# California Integrated Waste Management Board

RE: Assessment of Landfill Gas Monitoring Well Viability and Its Effect on Greenhouse Gas Emissions (IWM05046)

## Addendum No. 1 To the Request For Proposal (RFP)

# WELL DIAGRAM SHOWING PROBE DEPTHS

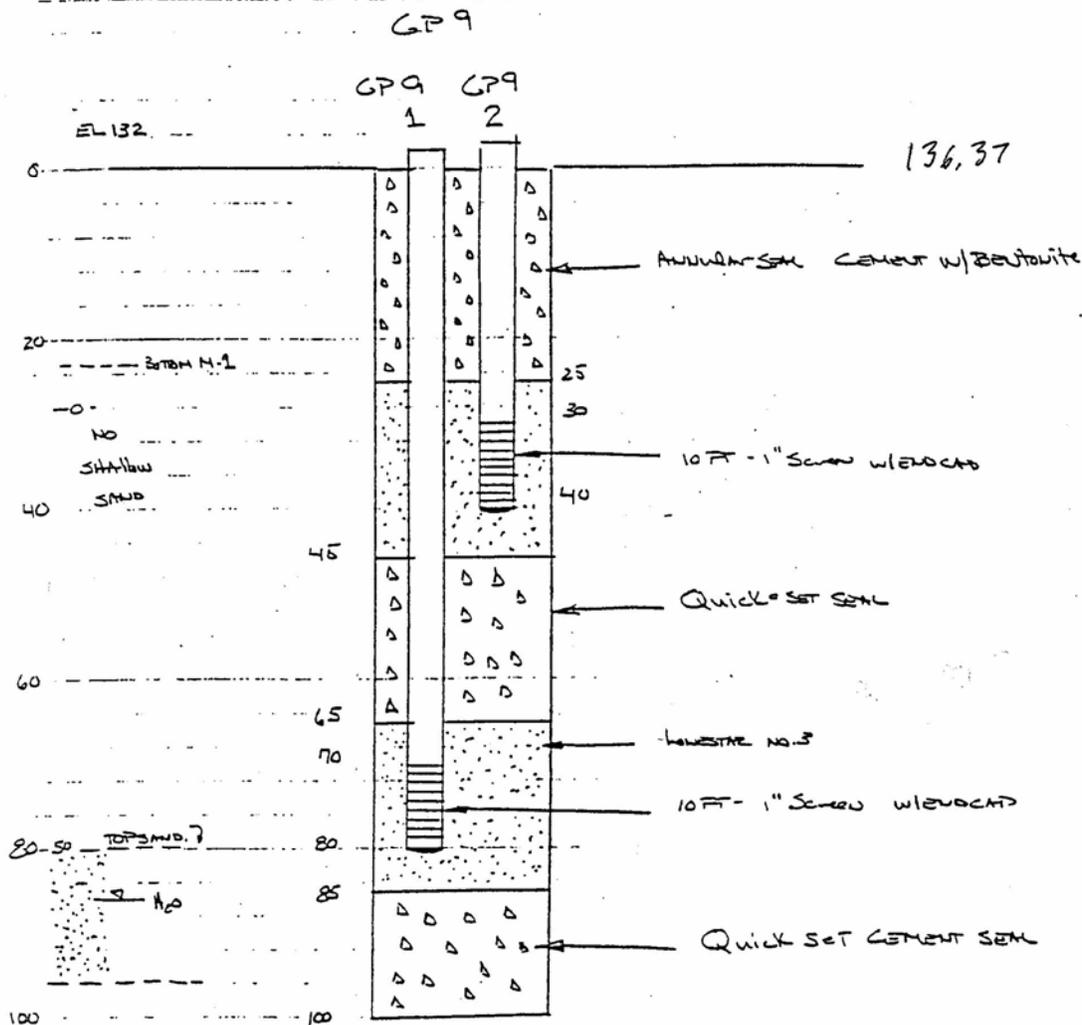
- Q4: Will the wells contain nested probes, or will they have single probes or both?
- A4: Most will have nested wells. Some are shallow, some are deep, but preferably we want to sample probes that are at least 35 feet deep if the sites allow. (A sample diagram showing probe depths Attachment 1 and a picture of a well with nested probes Attachment 2 is included in this Addendum.)
